**NHDPlus Release Notes for  
Region 07  
Last Updated 8/2/2010**

**Data Release Note – 8/2/2010 – Flowline\_Cat\_Attr V01\_02 Released**

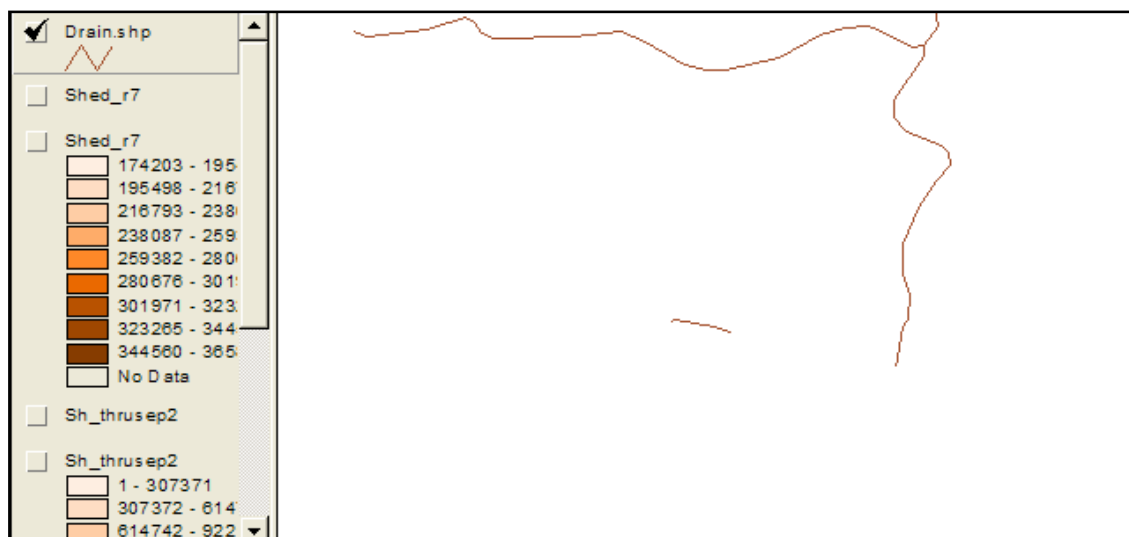
Comid 13079221 not in catchment shapefile. This is a single isolated flowline, 179 meters long (center of image), for which no catchment was delineated. It probably should not have been in the flow table in the first place. But since it was in the flow table, a catchment should have been generated.
